HBA16-002

Housing Variance requests for 818 Church Street Apartments 1 and 2.

Housing Board of Appeals Staff Report

Subject: HBA 16-002
818 Church Street, Apartments 1 & 2 cellar bedrooms

Drawing 1 - Unit 1

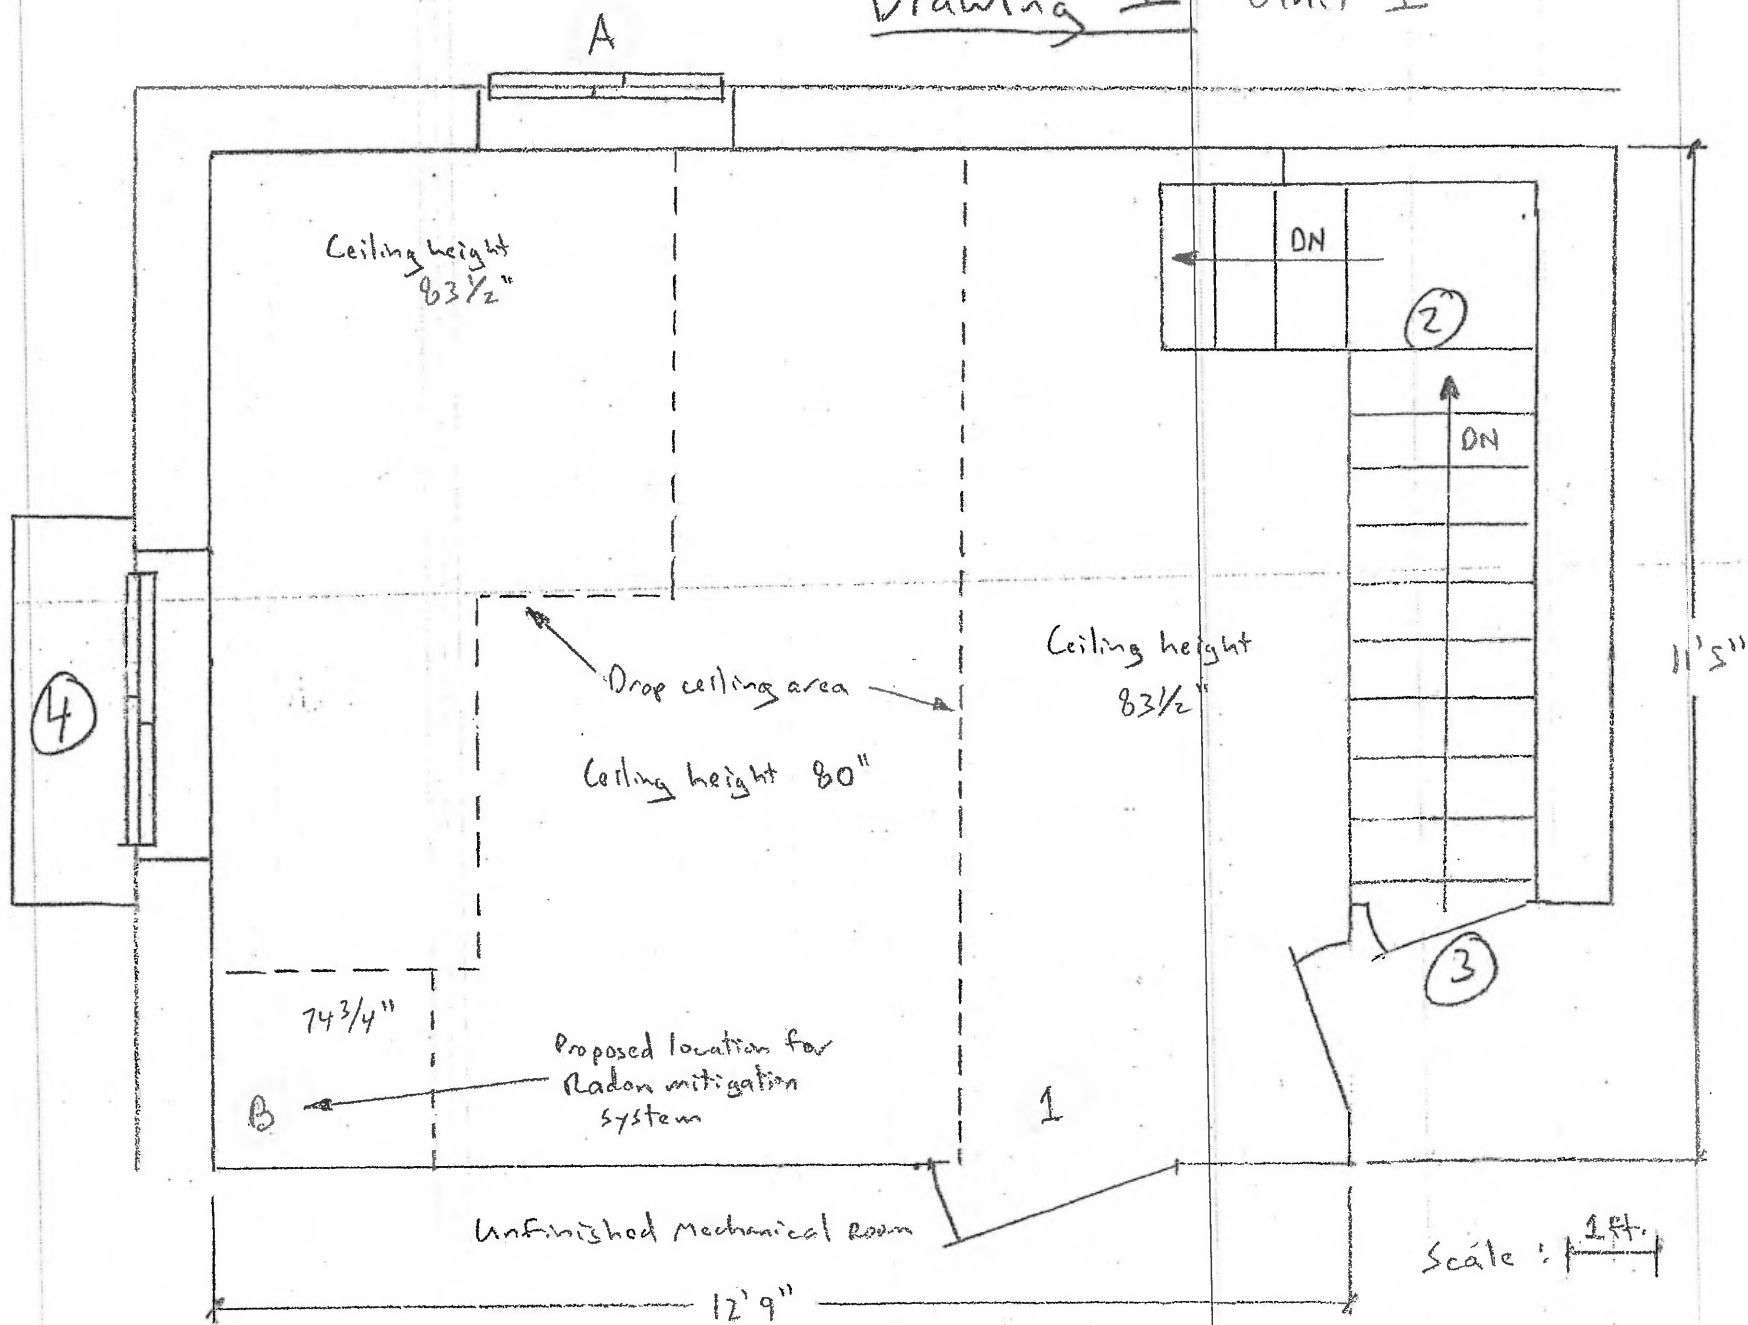
Requested variances for Apartment 1 cellar study (please refer to drawing 1 for reference);

1. 8:504 (3)(a)
 - o Requirement: 2nd means of egress.
 - o Proposed: Through a mechanical room with no ceiling, accessed directly from the cellar room through a self-closing, 32" fire door. The mechanical room has an existing overhead sprinkler. We have also already installed wireless, interconnected smoke detectors at the top and bottom of the basement stairs.

2. 8:504 (4)(b)(1)
 - o Requirement: 27" minimum stairway width.
 - o Proposed: 25". Current tread width measurement at the lower landing from 1st floor to cellar room. Overall stairway width is 37".

3. 8:503 (6)(n)
 - o Requirement: 22" required minimum at top of stairway.
 - o Proposed: 21". Existing clear opening width of door opening at the top of cellar stairs.

4. 8:503 (6)
 - o Requirement: 3'6" floor to grade height.
 - o Proposed: 4'9". Existing floor to grade height. There is a large, existing slider window that has a clear opening measurement of 18 ¾" x 30 ½" and a floor to sill height

A Radon test was completed on 3/4/2016 by Protech and the result was a reading of 8.5 for this room which would require a Radon mitigation system. Protech has already received a signed proposal for installing this system and is in the process of scheduling the work (see item B on drawing 1.) This will most likely occur sometime in May 2016.

Staff is not opposed to the variance provided that interconnected smoke alarms are maintained at the top and bottom of cellar stairs, the overhead sprinkler is maintained within the mechanical room, and a carbon monoxide detector is maintained within the mechanical room.

A radon test should be performed within apartment #1 cellar after the installation of the radon mitigation system to ensure safe levels of radon have been achieved prior to occupancy of the apartment #1 cellar space.

Staff is not opposed to the variances and recommends a contingency to maintain interconnected smoke alarms at the top and bottom of the apartment #1 stairs.

Drawn: 2 - Unit 2

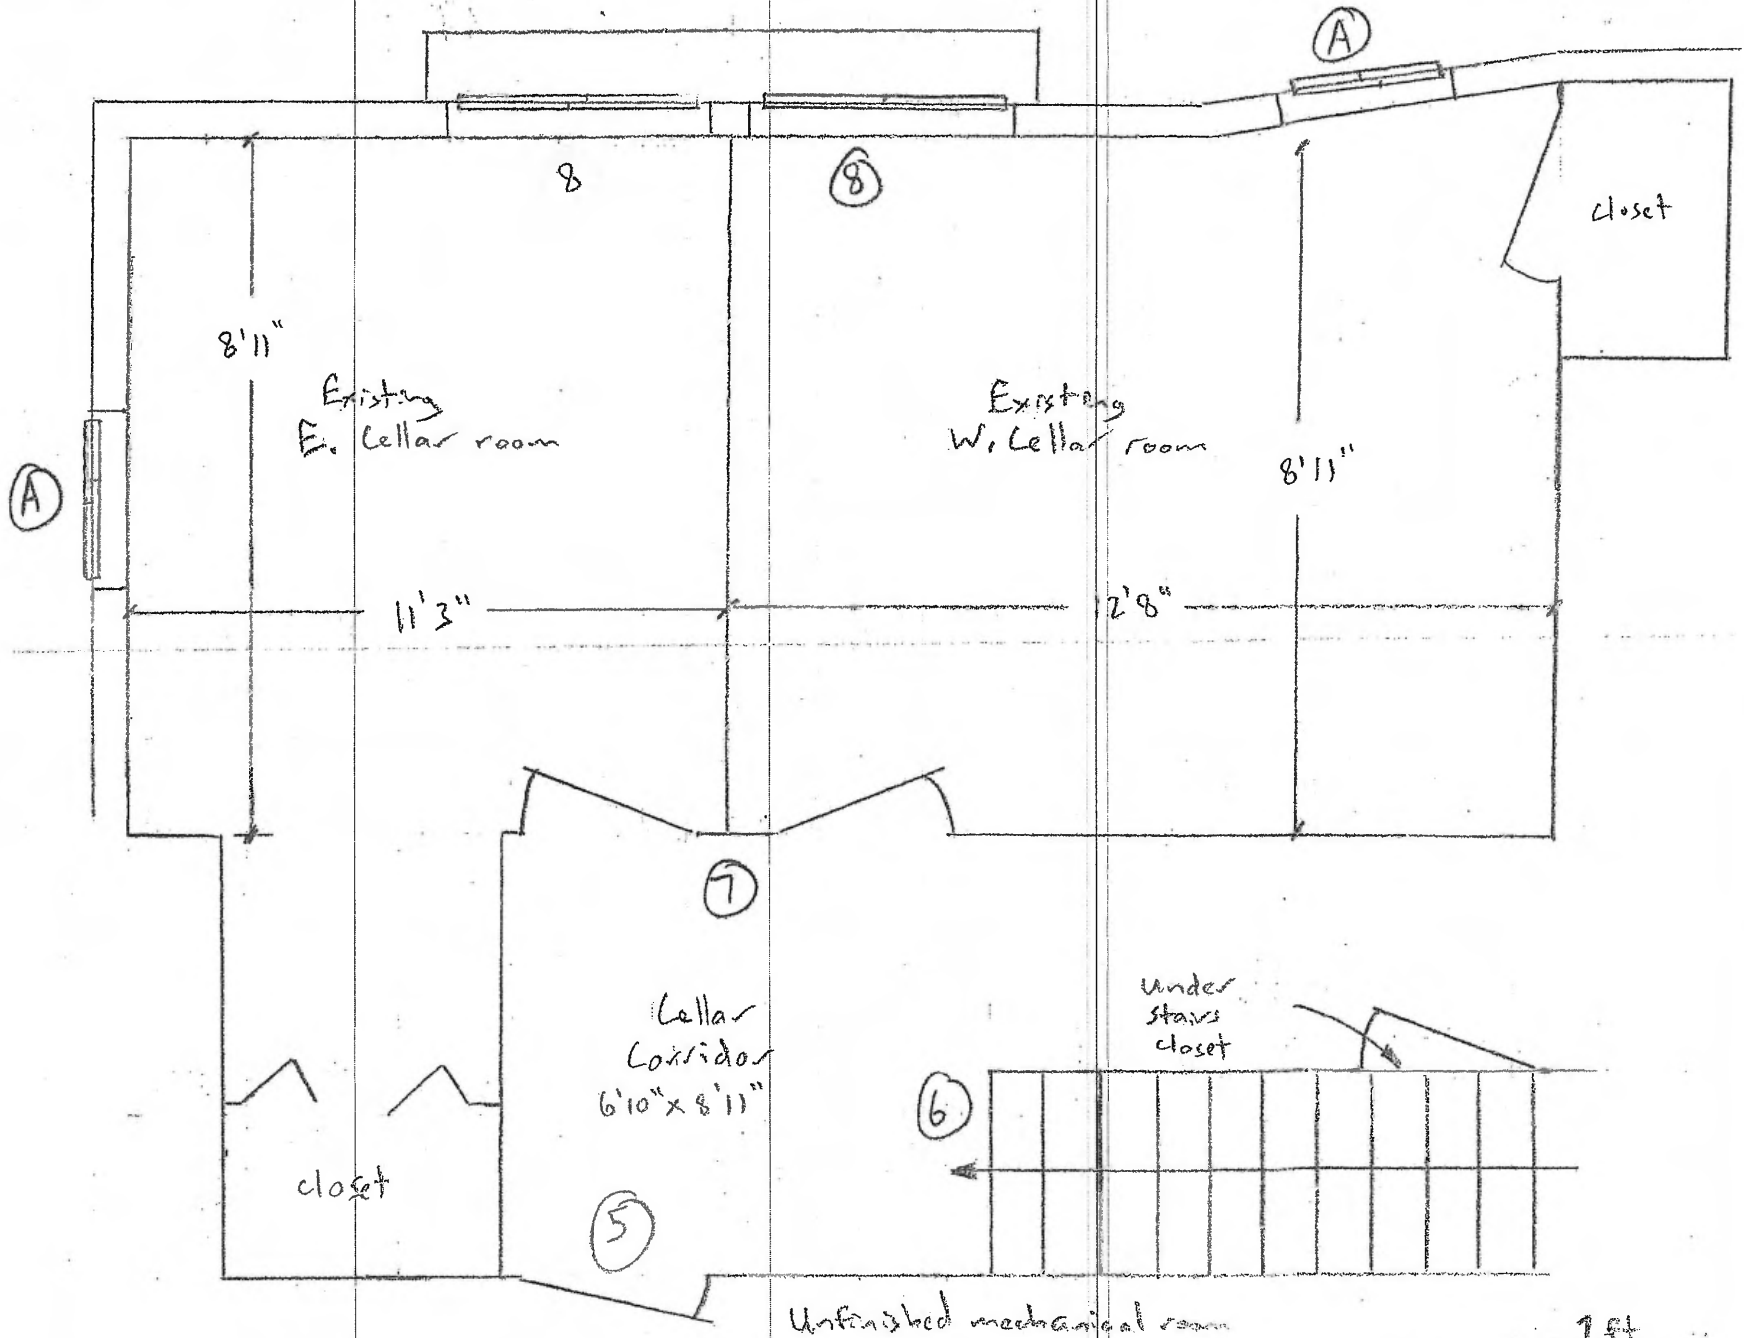
Requested variances for Apartment 2 west cellar study (please refer to drawing 2 for reference);

5. 8:504 (3)(a)
 - Requirement: 2nd means of egress.
 - Proposed: Through a mechanical room with no ceiling, accessed directly from the unit cellar corridor through a self-closing 32" fire door. The basement corridor immediately outside this west cellar room has an existing drywall ceiling and sprinkler head and the mechanical room does not have a ceiling but also has an existing overhead sprinkler head. We have also already installed wireless, interconnected smoke detectors at the top and bottom of the cellar stairs of apt. 2.

6. 8:504 (4)(b)(2)
 - Requirement: 6'0" minimum headroom height at base of stairway.
 - Proposed: 5'9". Existing headroom at bottom of cellar stairs.
7. 8:504 (4)(a)(2)

- Requirement: 6'6" minimum headroom in corridor outside cellar room.
 - Proposed: 6'4". Existing headroom in cellar corridor outside of room.
8. 8:503 (6)

- Requirement: 3'6" floor to grade height.
 - Proposed: 4'9". Existing floor to grade height. There is a large, existing slider window that has a clear opening measurement of 18 ¾" x 30 ½" and a floor to sill height of 50 ½" for egress access. With an exterior window well that is only 14" deep and is 29" x 111".

Staff is not opposed to the variances and recommends a contingency to maintain interconnected smoke alarms at the top and bottom of the apartment #2 stairs.

Item 3- Unit 1- Door opening at top of cellar stairs. Existing clear opening of 21". Wireless, interconnected smoke-detectors are at the top and bottom of stairs

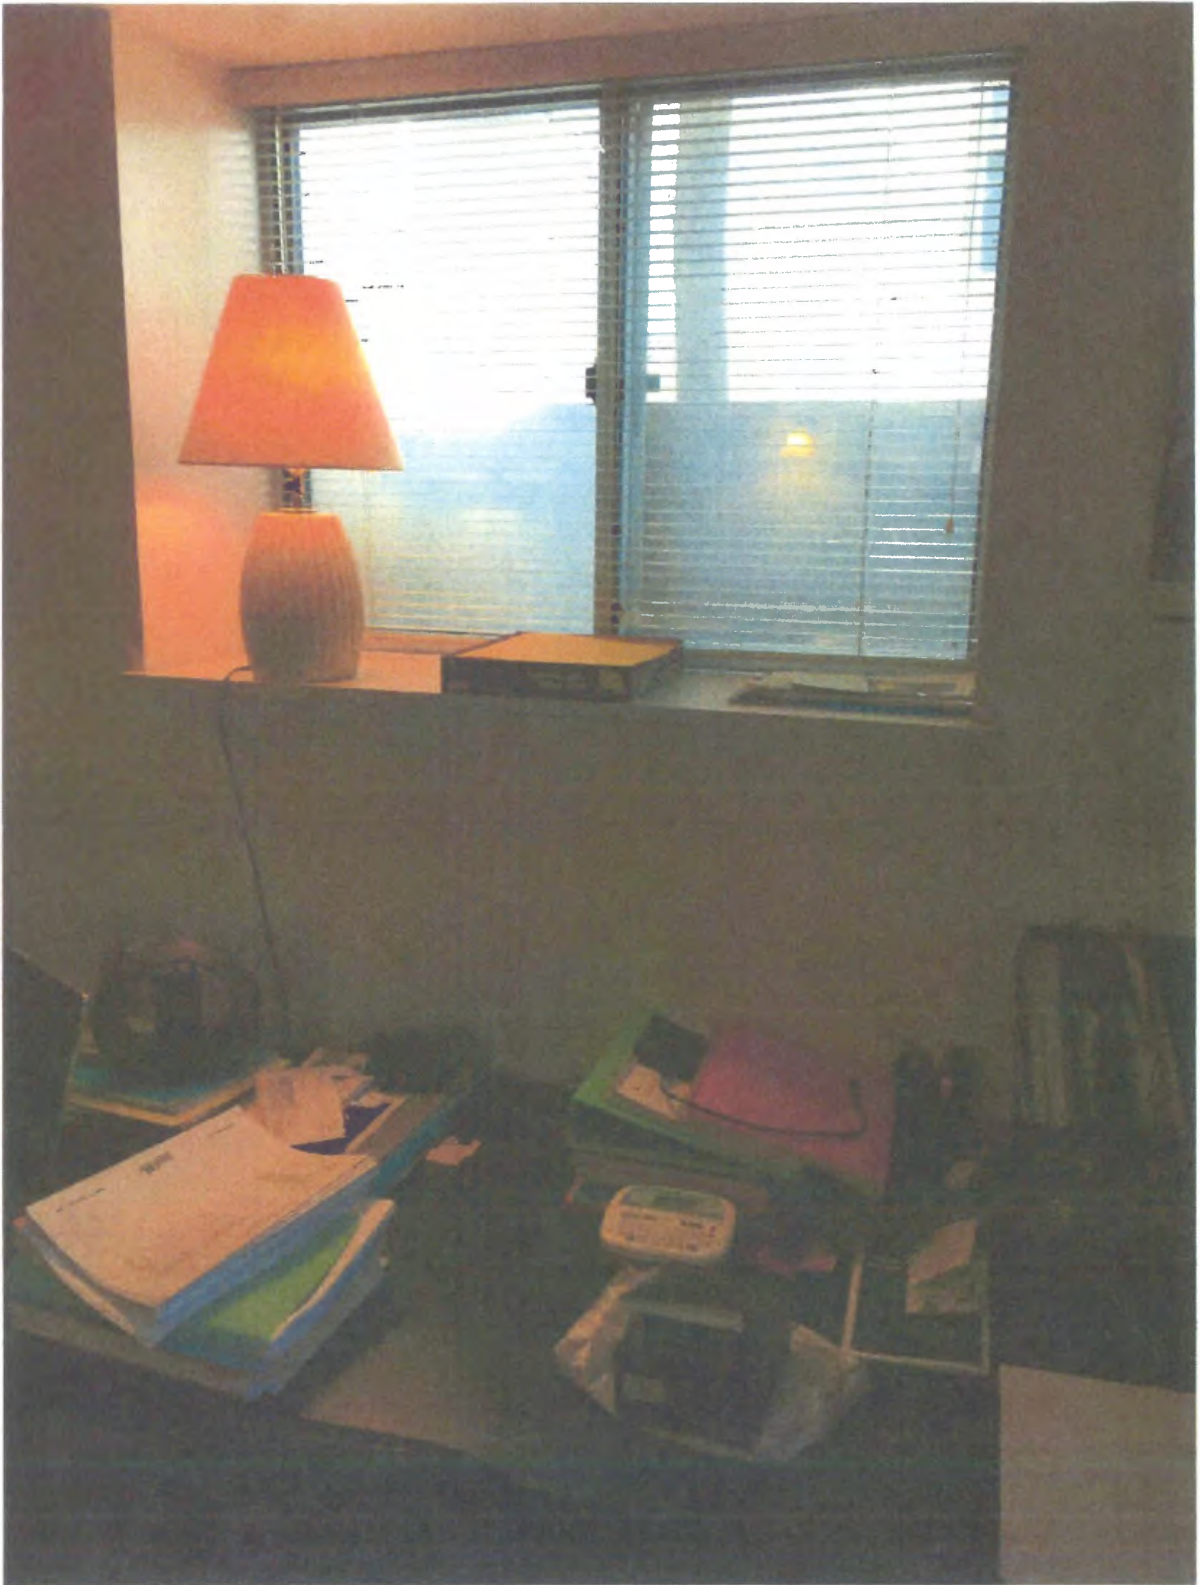
Item 2- Unit 1 cellar stairs. 25" tread-width at bottom of stairs. Wireless, interconnected smoke detectors are at the top and bottom of stairs.
